<b>ATTENTION</b>	Expert Consenting Panel - Ashbourne
<b>SUBJECT</b>	Response to Minute 11 (Point 13) and Minute 13
<b>AUTHOR</b>	Clare Houlbrooke

This memorandum provides a response to Minute 11 (Point 13) and Minute 13, the Ashbourne Development.

**Figure 1: Basin A Moundsolv Map**

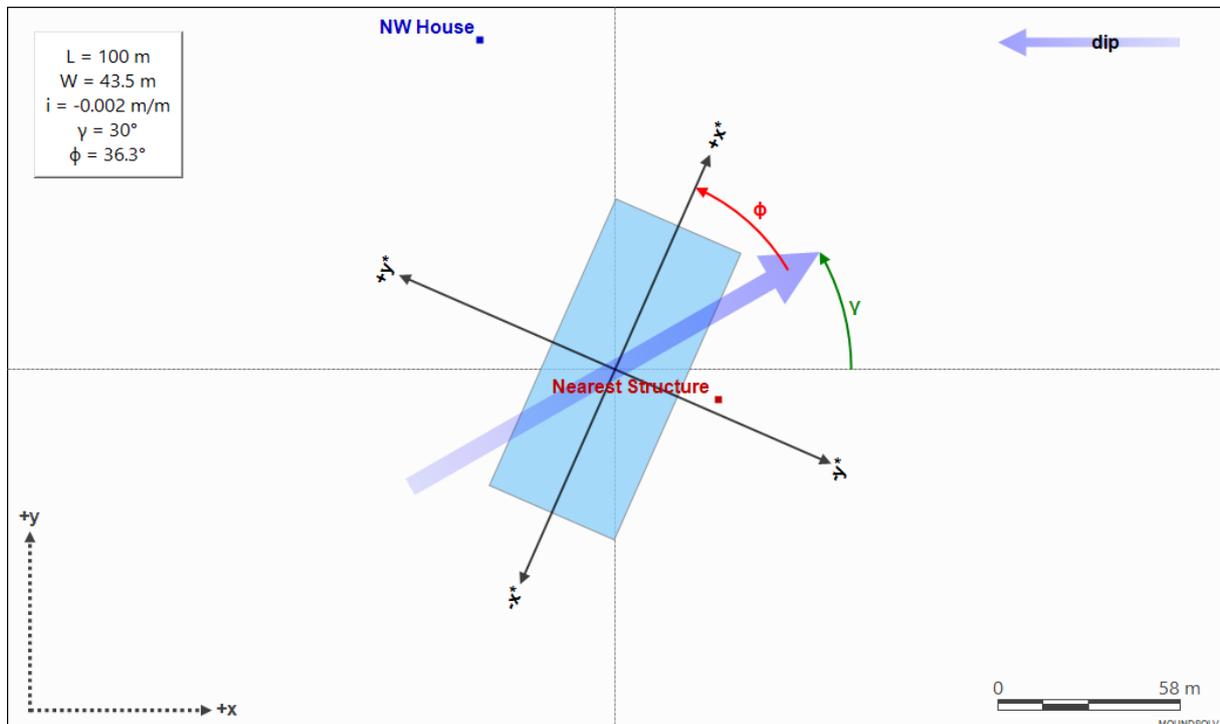
The WGA memo dated 18 November 2025 provides the infiltration rates derived from the modelling in Table C1 for Basin A (labelled “Model Output”).

In addition, there are model image files that were generated but not included in the November memo and two of these images are included below in Figure 1 and Figure 2 for further information on the results.
